PRELIMINARY DRAINAGE REPORT

FALCON MEADOWS AT BENT GRASS

Engineering Review

PUDSP-20-005

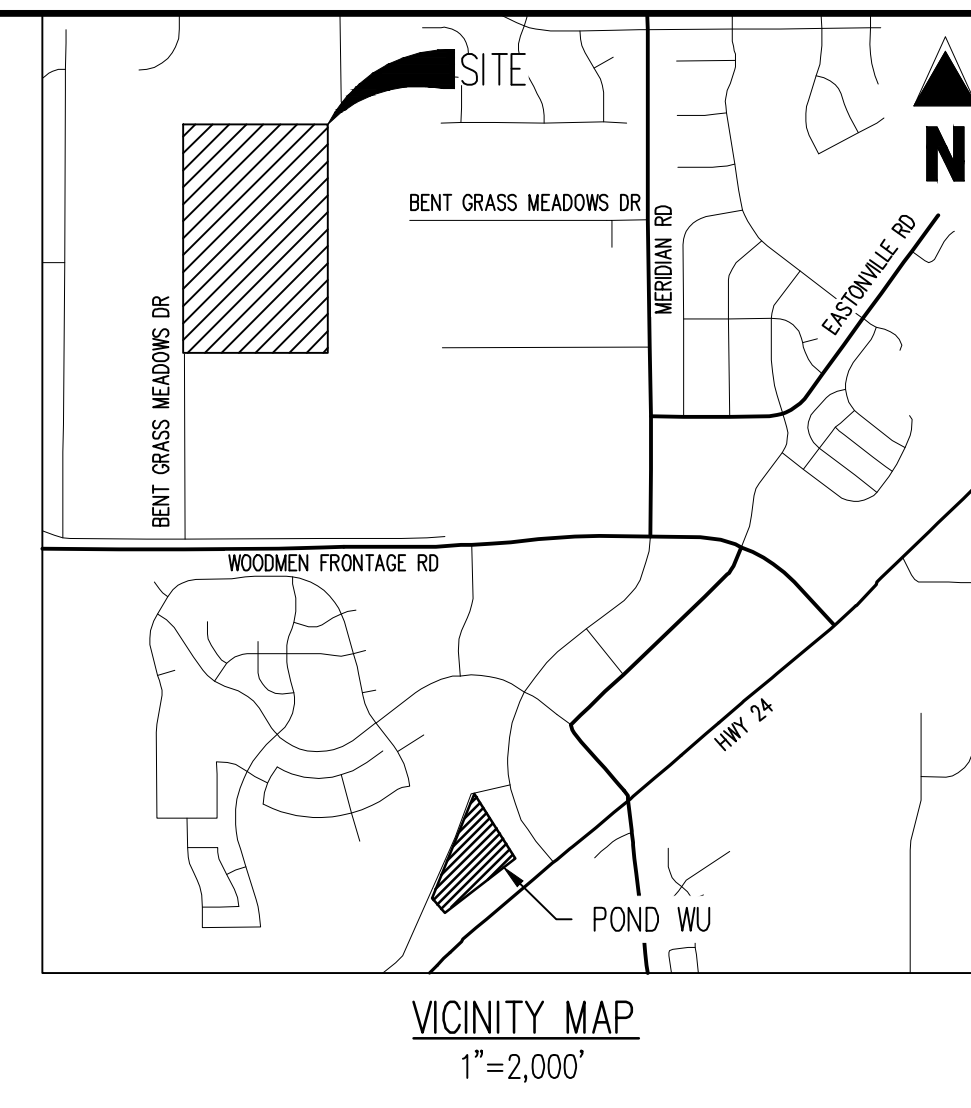
grate velocity is dangerous - larger box size is recommended

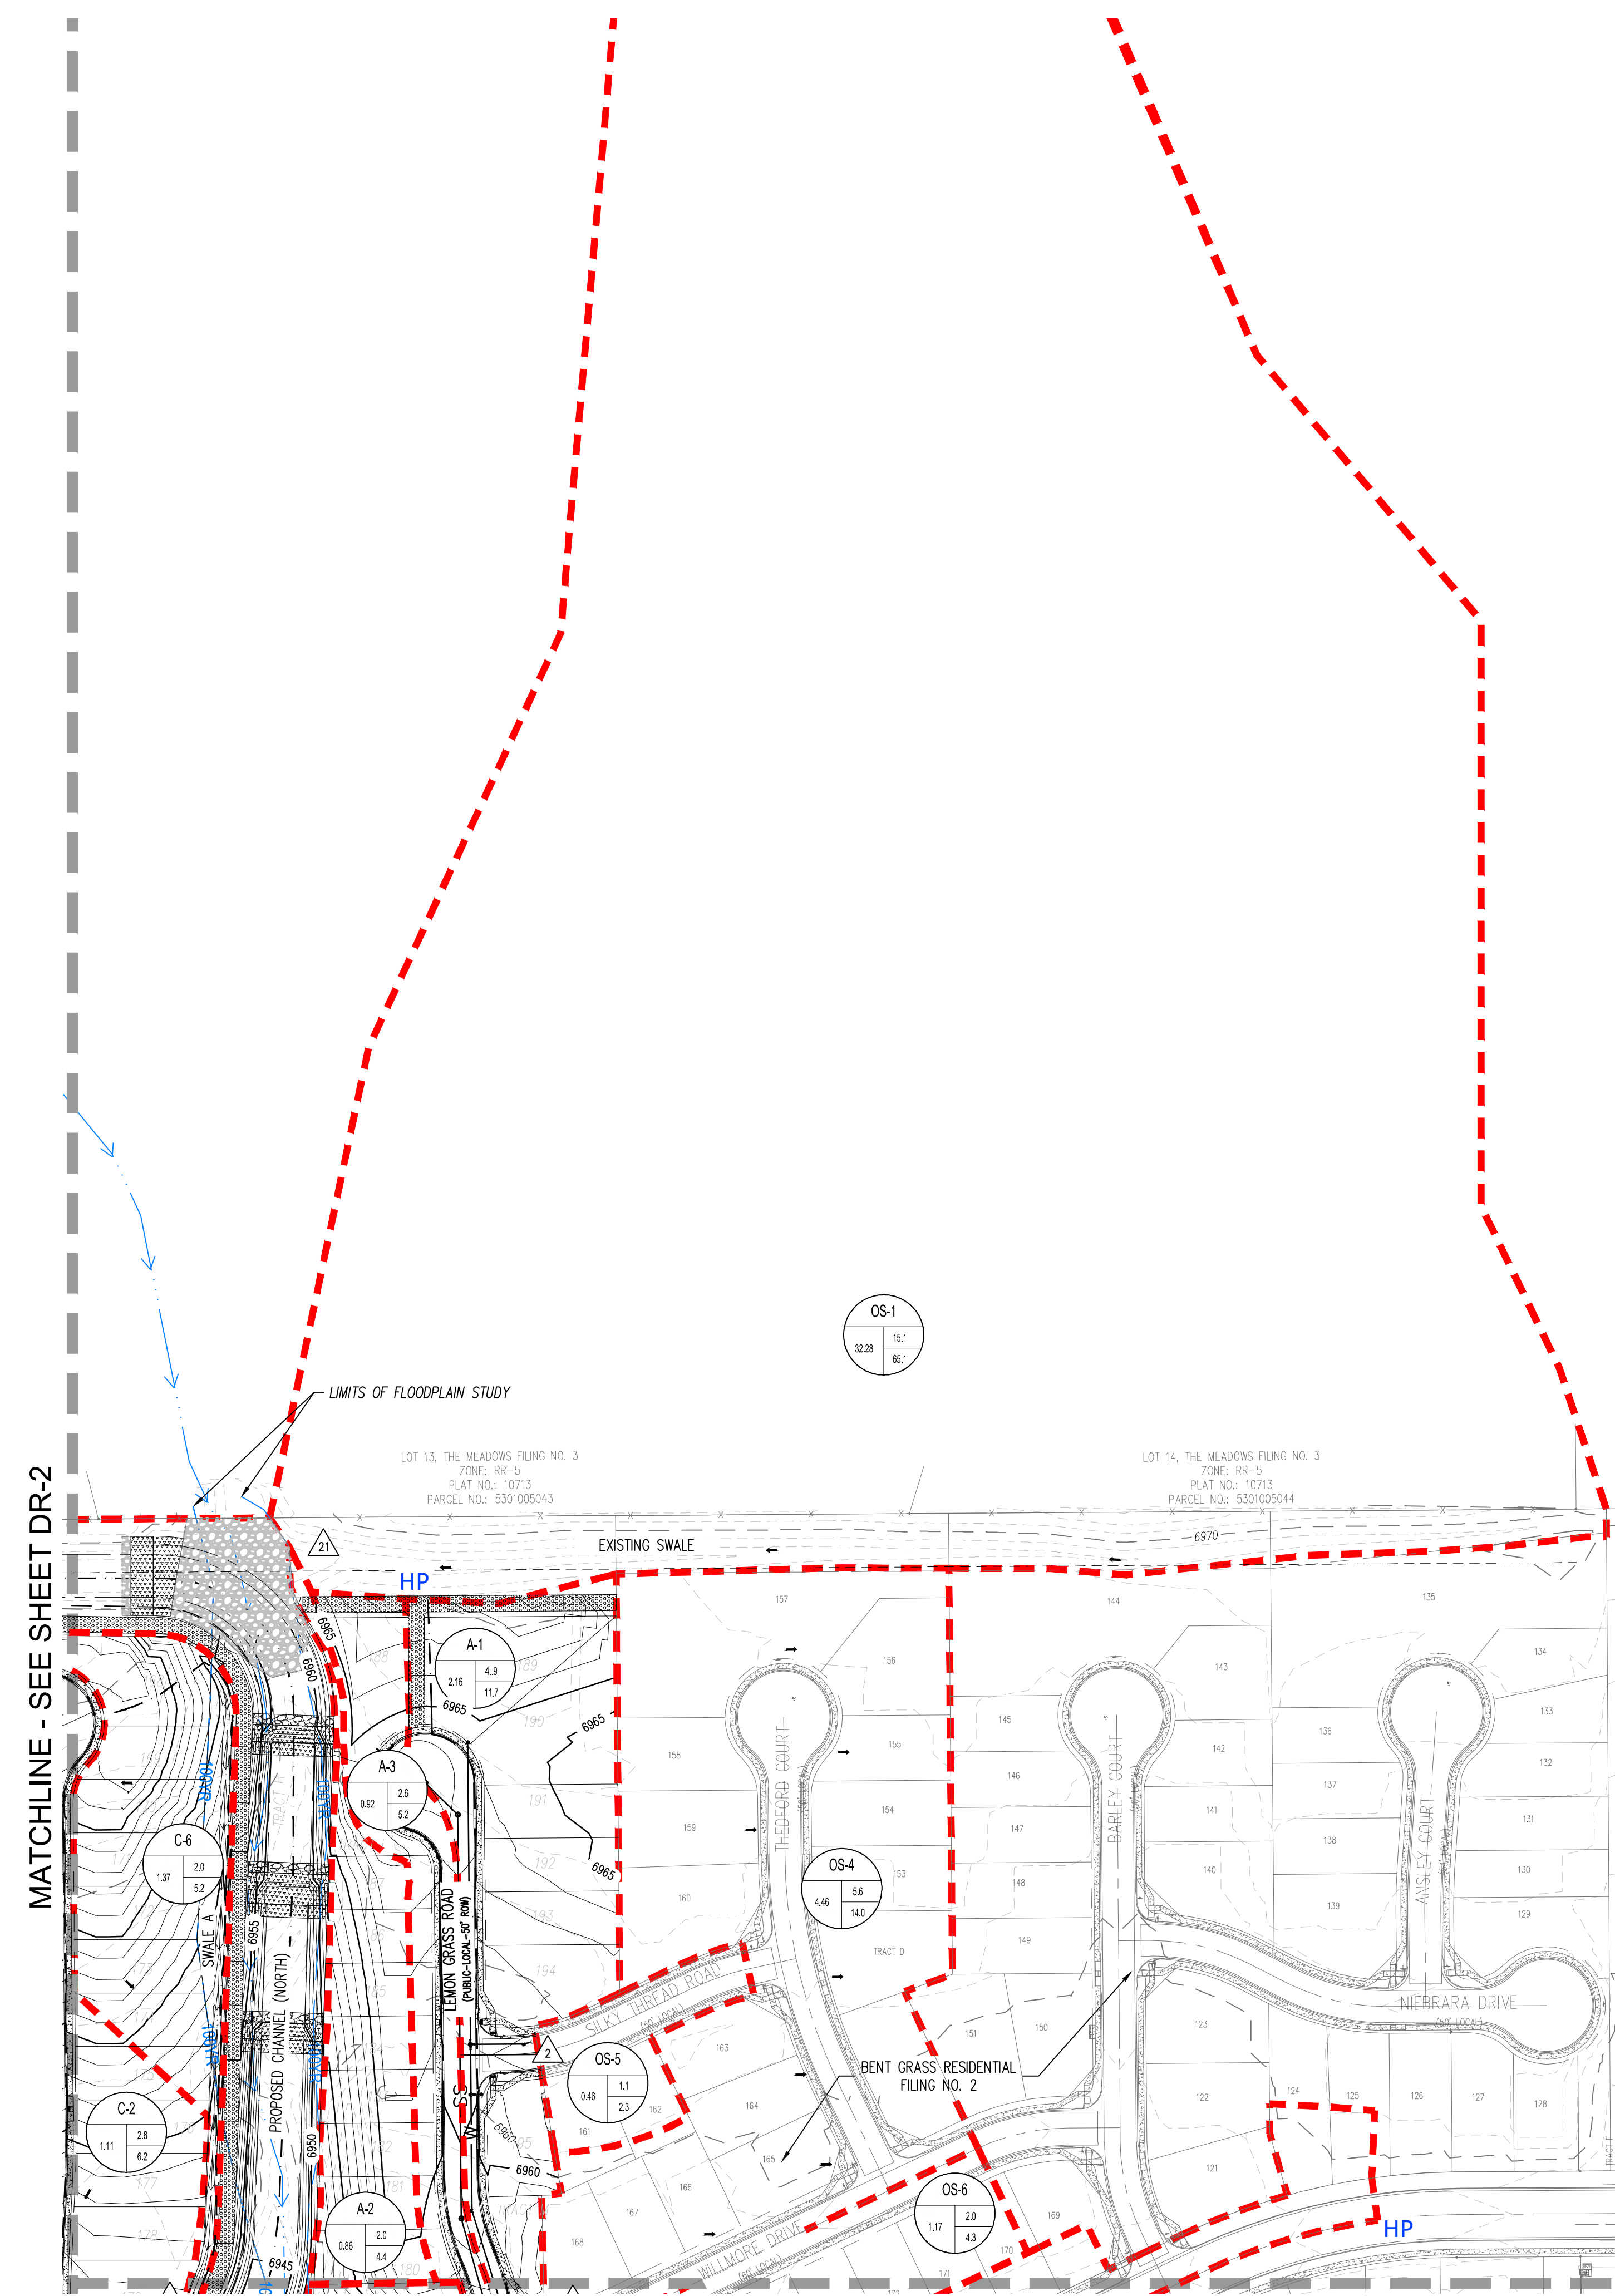
Add combined DP at N channel

Provide DP 22
